APPENDIX 3
Mitigation Issues SEP 24 2010

Abstract

Misclassification of Stream Resources

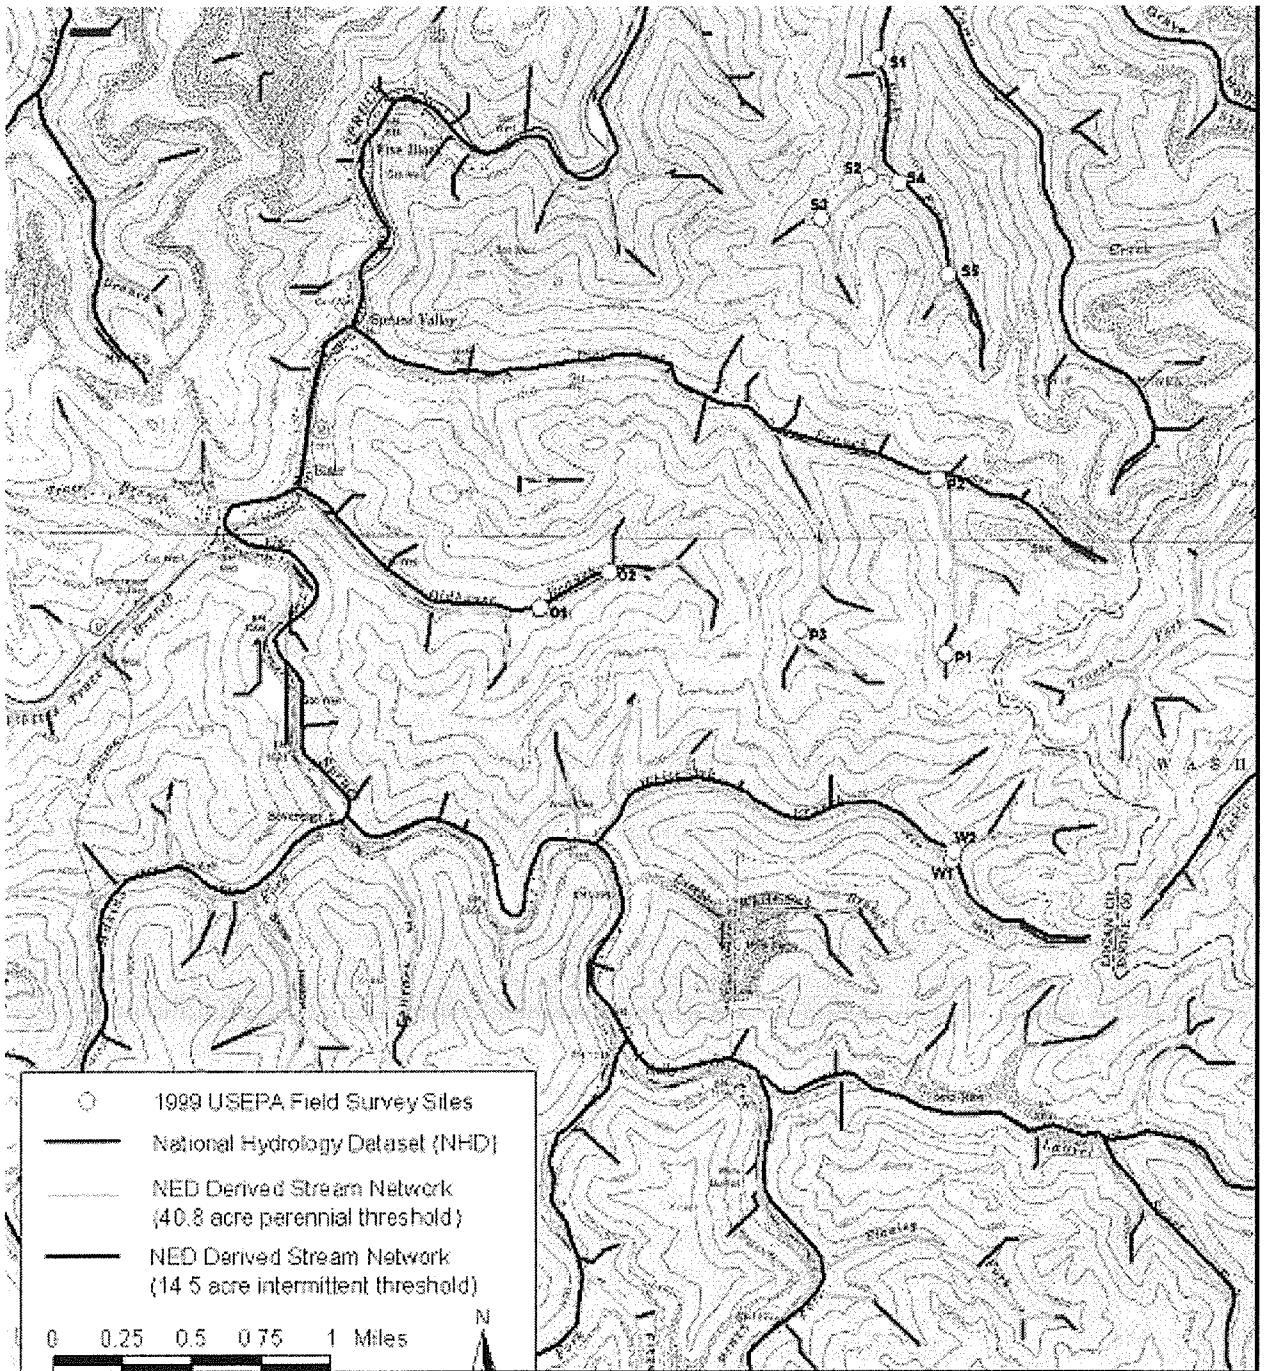
Based on these new scientific studies and previously collected field data, EPA believes that all proposed valley fills will impact previously undelineated segments of intermittent and perennial stream channels. An example of mischaracterization is in Oldhouse Branch. The uppermost ephemeral/intermittent delineation point (T1; CMP Final Exhibit 2-Stream Delineation Map) occurs at approximately the 255 acre watershed size (this corresponds the Green and Passmore, 1999 site O1 in Figure 1). At this watershed size, EPA contends that a strong perennial stream channel is present for thousands of feet upstream of this point. Figure 1 shows an excerpt from a 7.5 min USGS topographic map depicting Green and Passmore (1999) study sites, overlain with Paybins (2003) drainage-area derived intermittent and perennial delineations.

EPA compared lengths of stream channel in Pigeonroost, Seng Camp, and Oldhouse from USGS estimates, to field delineations made by the applicant. As an example, it is EPA's determination that at point T1 (mentioned above) in Oldhouse Branch (the applicant's

demarcation for ephemeral/intermittent found in CMP Final Exhibit 2-Stream Delineation Map) that there are approximately 3100 feet of unaccounted for perennial stream above that point. Moreover, in Oldhouse, an additional 1100 feet in "Second Unnamed Right Tributary" (T2 in CMP Exhibit) probably run perennially. By adding the additional distance from T1 down to the toe of the proposed fill, it is probable that there are over 7000 cumulative feet of perennial stream channel that will be mined-through or filled in Oldhouse Branch alone. This is in contrast to the <200 feet determined by the applicant.

In Pigeonroost, EPA believes that additional stream lengths, which have been classified as ephemeral or intermittent by the applicants, are likely perennial waters. Again, the EPA study (Green and Passmore, 1999) used the WV water quality standards methodology for determining perennial streams and was conducted during a relatively dry, late summer period. The study found WVDEP Type 1 (flow and indicator biota requiring 6 mo. life cycle) and Type 2 (intermittent flow but indicator biota requiring 6 mo. life cycle) perennial conditions near the very headwaters of Pigeonroost. Additionally, one site in upper Middle Fork of Pigeonroost (P1 in Figure 1) with a catchment area of only 15 acres was also deemed to be a Type 1 perennial stream.

Figure 2. Reclaimed sediment ditch: Anna Branch (Logan Co., WV).

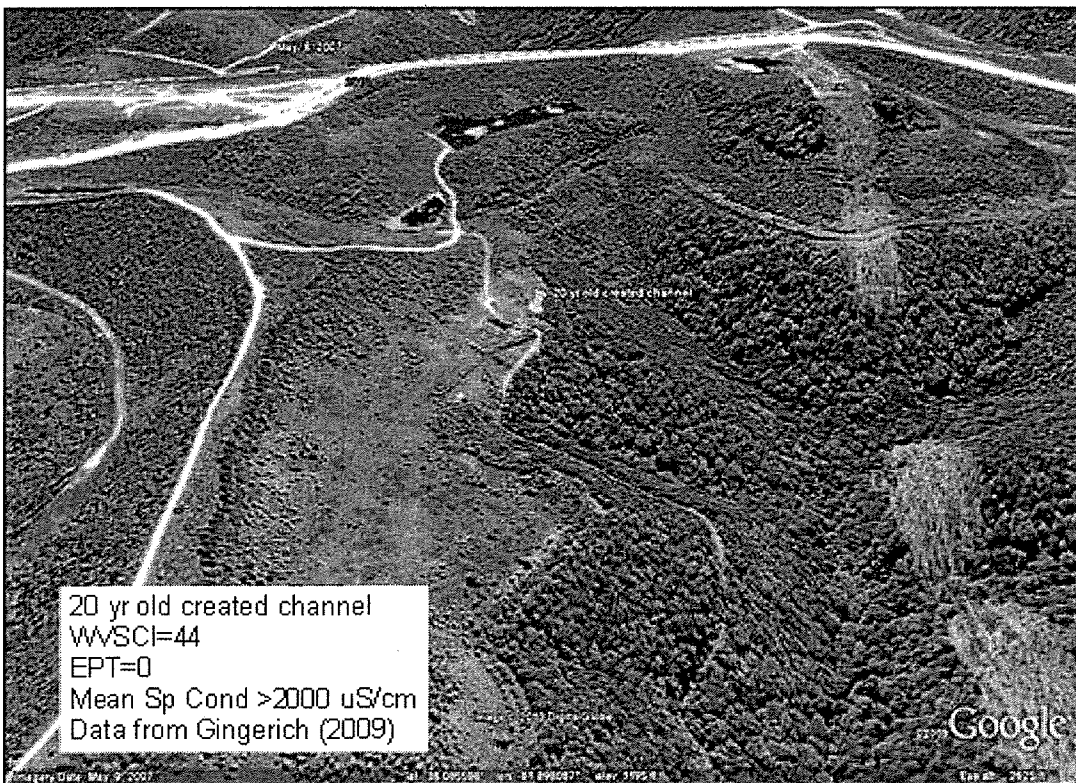
The following Figures 2 through 3 show aerial views of examples of on-bench sediment ditches with the accompanying biological and physicochemical data. EPA has observed the following conditions in these sediment ditches, in comparison to natural high-gradient streams:

- 1) Altered flow regime (e.g., unnaturally low velocities)

- 2) Altered temperature regime (e.g., extreme high temperatures)
- 3) Severely contaminated water (e.g., ions, metals)
- 4) Depauperate and tolerant biota (e.g., typical of roadside ditches/urban swales)
